FRAMATOME ANP

March 10, 2003
NRC:03:011

Downcomer Boiling in Framatome ANP PWR ECCS Evaluation Models

Attachment A Evaluation of Downcomer Boiling

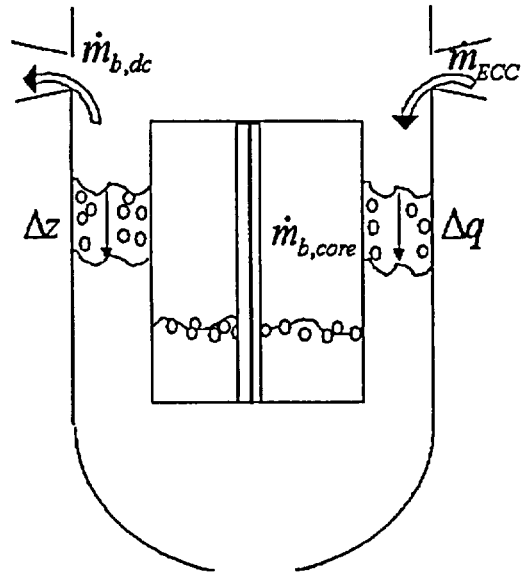
Question 27: *The brief overview and description of large break LOCA behavior on Page 3-4 does not mention the potential for downcomer boiling. Downcomer boiling has been shown to be important in the transport of coolant to the core in the LBLOCA. Discuss the basis for the applicability of the S-RELAP5 simulation of the effects of downcomer boiling and the manner in which downcomer boiling has been treated in the RLBLOCA methodology. Include in the discussion the roll of the downcomer wall initial temperature in downcomer boiling.*

The PIRT in Table 3.3 does not include downcomer boiling. Please include in the discussion the exclusion of downcomer boiling from the PIRT.

Hot downcomer walls penalize PCT by two mechanisms: reducing subcooling of coolant entering the core and by the loss of coolant mass out the break from boiling along the downcomer ($\dot{m}_{b,dc}$, see figure at right). These processes reduce the density of the downcomer fluid and effectively lower the height of the liquid column in the downcomer which reduces the pressure driving force for reflooding the core. While boiling in the downcomer may occur at anytime during a LBLOCA transient, the biggest impact on clad temperatures will occur during late

reflood following the end of accumulator injection. At this time, there is a large step reduction in coolant flow from the ECC system ($\dot{m}_{ECC}$ in figure) and, at this same time, the coolant subcooling is being lost due to heat input from the downcomer metal mass. When this coolant becomes saturated, boiloff occurs which further reduces the effective downcomer level. With the reduction of the downcomer liquid level, the core reflood rates will be reduced and the clad temperatures will increase.
